# Technical Reclamation Memorandum

## TRM # 11

Kentucky Department for  
Surface Mining Reclamation  
and Enforcement

Subject: New Interpretation of the EPA  
Settleable Solids Effluent  
Limitation

Figure B-2 Sediment pond area-capacity curves.

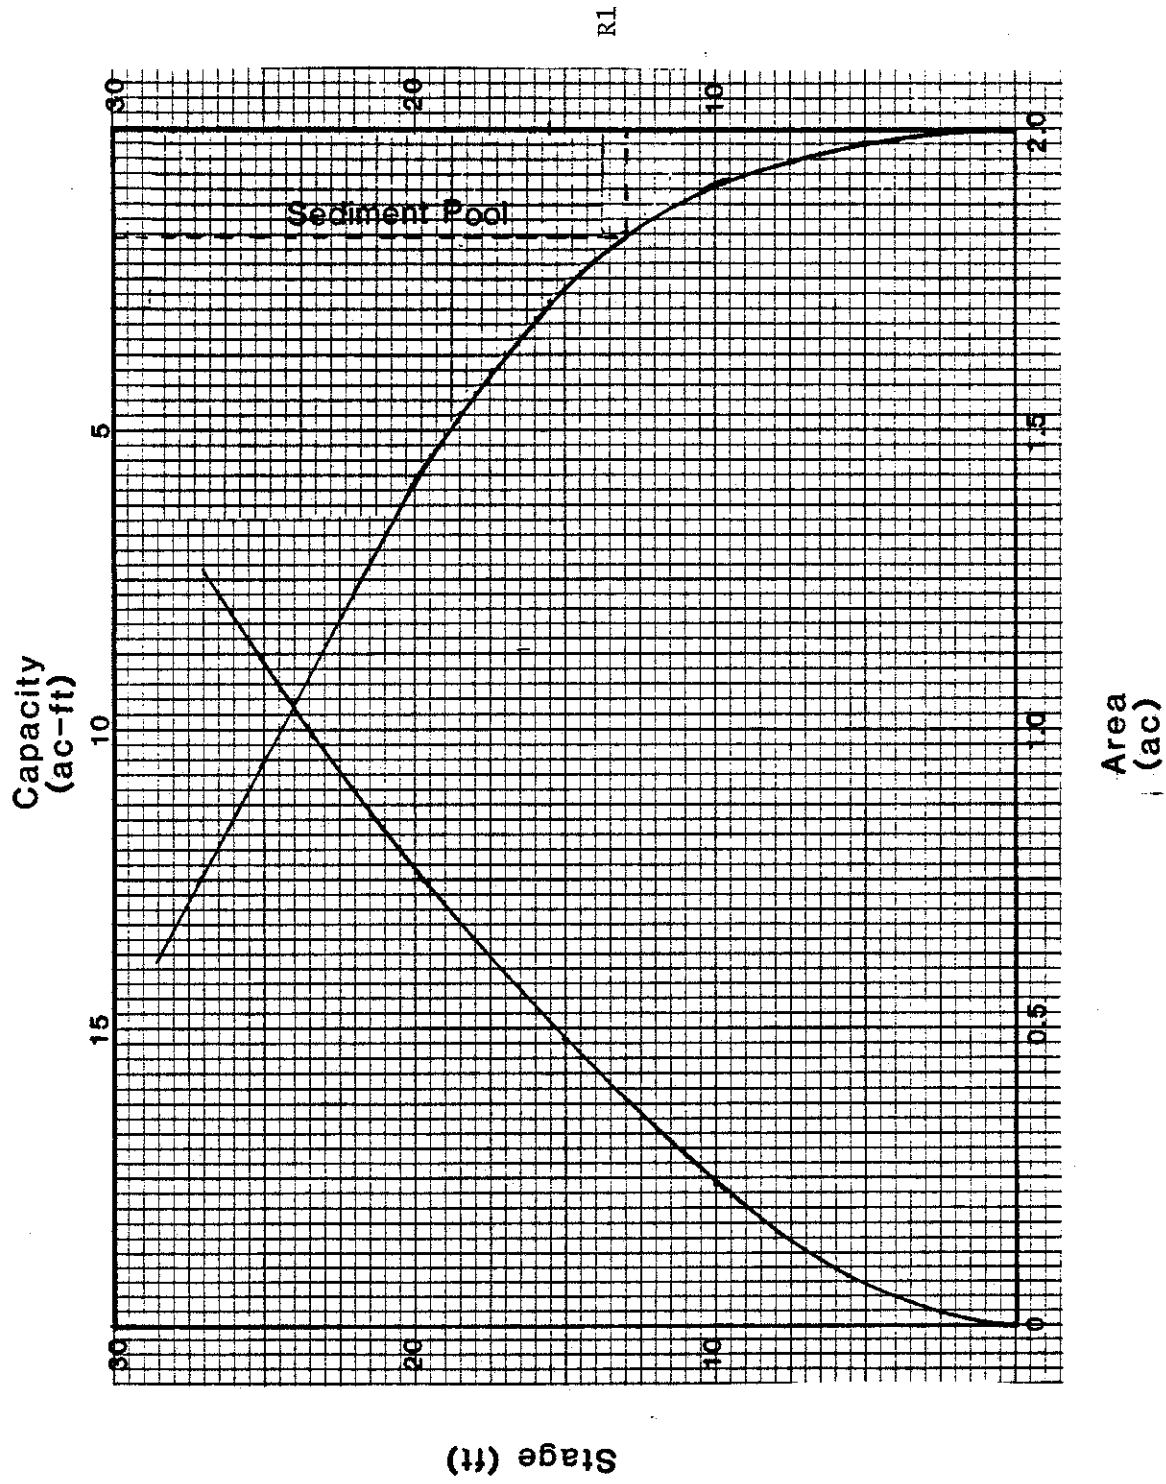
- (4) Example contained in Appendix B; pp. B-6 through B-8, B-14 through B-17, and B-21.

The sediment storage volume of 2.63 acre-feet used in the example is greater than that needed to meet the minimum of 1.5 times the 10-year, 24-hour storm sediment volume. The correct minimum sediment storage volume is 1.76 acre-feet. The discussion on pages B-6 and B-7 and worksheets 4, 5 and 6 have been updated to reflect this change.

As previously noted, the Example 1 operation has a disturbed area of 18.8 acres. Providing a sediment pool volume of 0.075 acre-feet per acre disturbed yields a sediment pool storage volume of 1.41 acre-feet. However, using equation 15 to determine the minimum sediment storage volume (1.5 times the 10-year, 24-hour storm sediment load of 1990 tons) produces a sediment pool of 1.76 acre-feet. The sediment pool elevation corresponding to a volume of 1.76 acre-feet is 13.0 feet (Figure B-2).
